# Technical note

<b>Project:</b>	Albion Gateway	<b>To:</b>	Dave Hughes (East Staffordshire Borough Council)
<b>Subject:</b>	Response to LLFA comments regarding planning application reference P/2017/00141	<b>From:</b>	Atkins
<b>Date:</b>	21 Apr 2017	<b>cc:</b>	Ian Romano (St. Modwen Developments), Rob Barnes (Planning Prospects)

This technical note has been produced in response to Staffordshire County Council's Lead Local Flood Authority Planning Application response dated 11/04/17 within which East Staffs Borough Council have made comment.

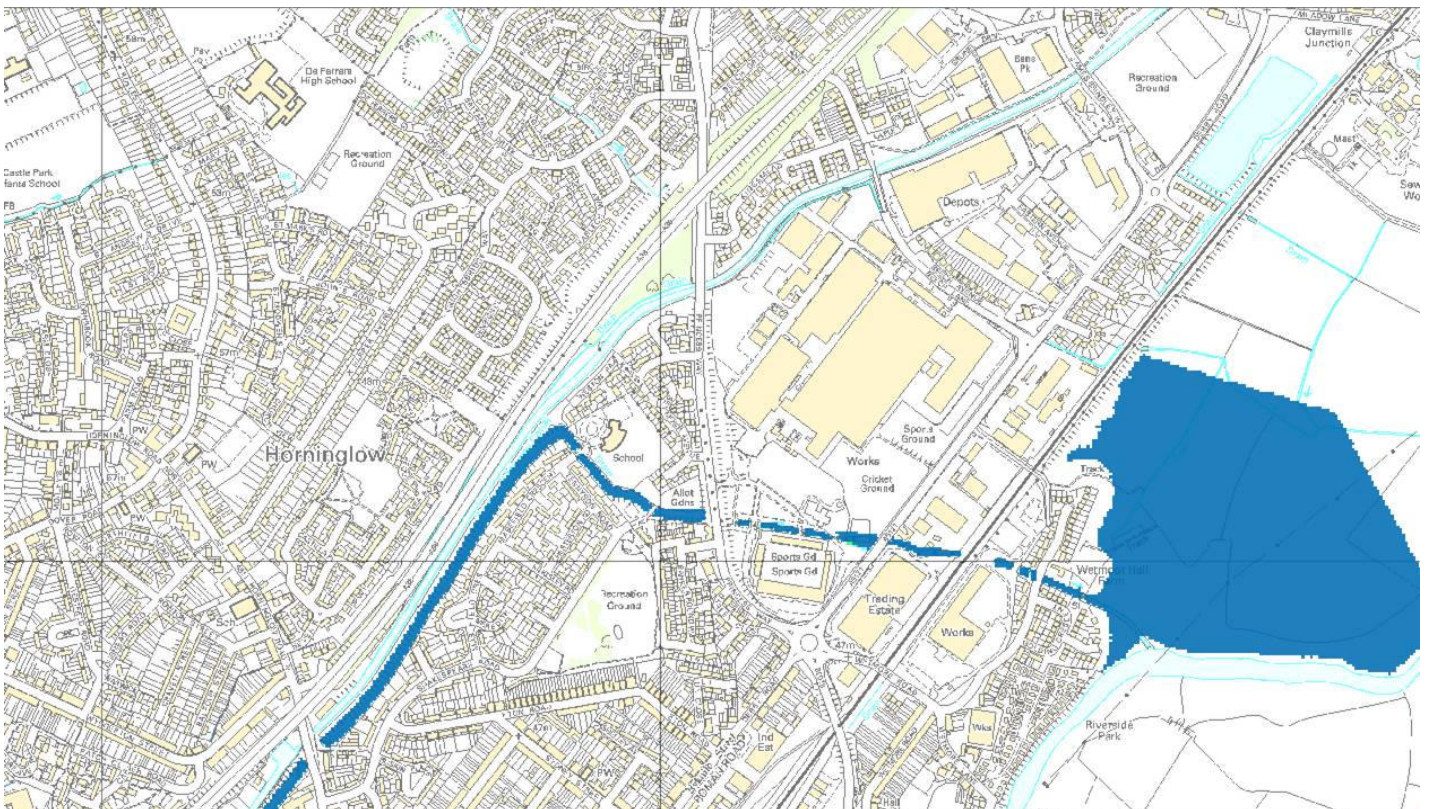
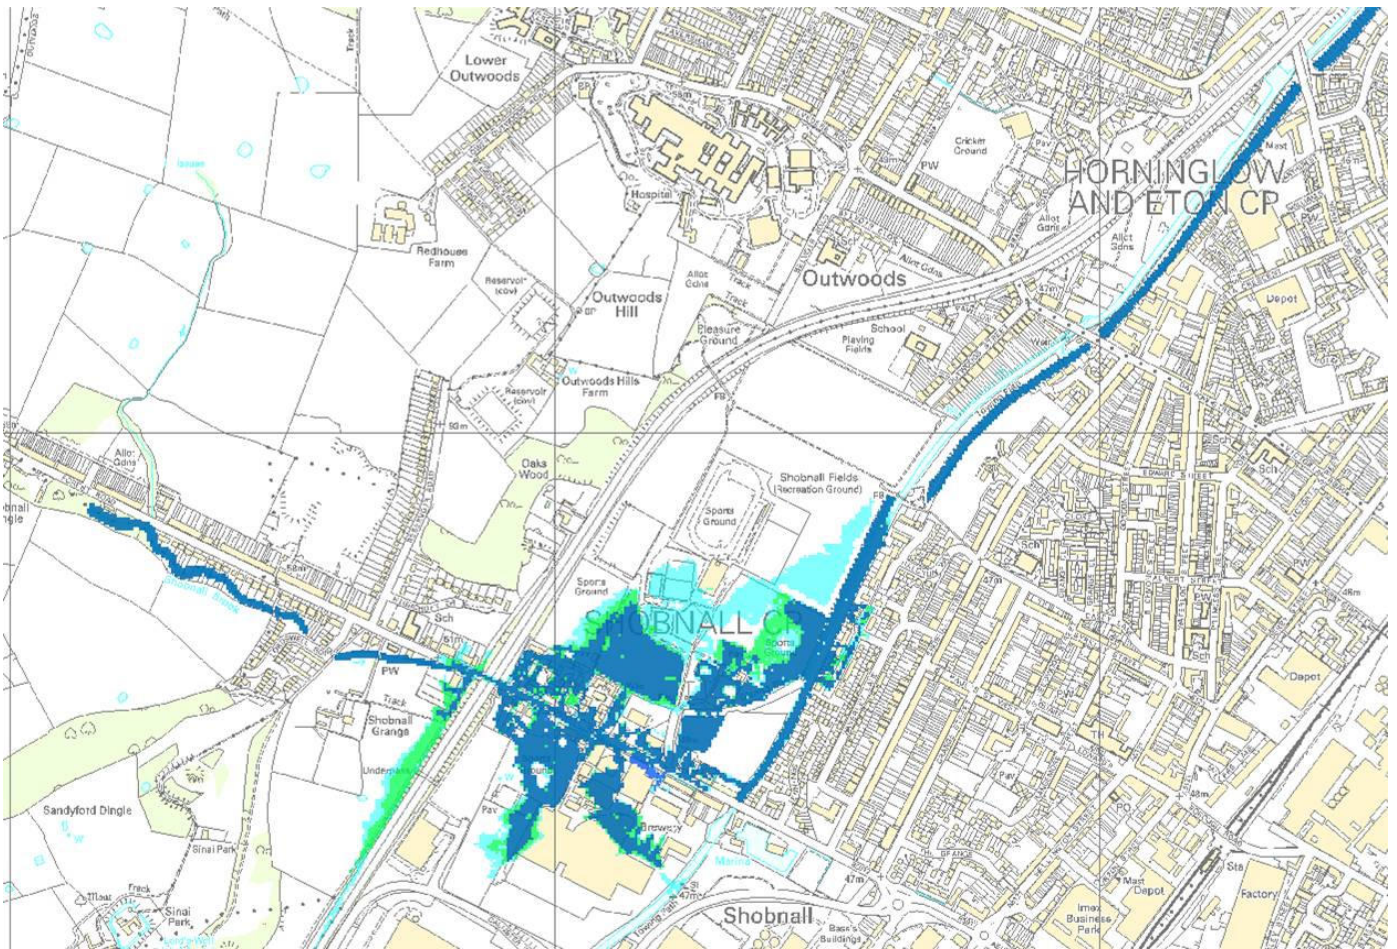
As discussed, the information I sent through last night related to a superseded model run where the boundary of the River Trent had been set to the 1 in 100 year event (which is very conservative). We had got this rectified with our hydrological consultant and the new Shobnall Brook modelling (Jan 15) uses a 20 year boundary on the Trent (much more reasonable). The most recent mapping is shown below (Dark Blue = 100yr, Light Green = 100yrCC, Light Blue = 1000yr). As you can see, the Pirelli site is flood free for all scenarios. This is attributable to the fact we have a lot of culverted sections of the brook upstream which forces a substantial amount of water out of bank into the surrounding floodplain, leading to only a limited flow reaching the downstream sections adjacent to the Pirelli site.
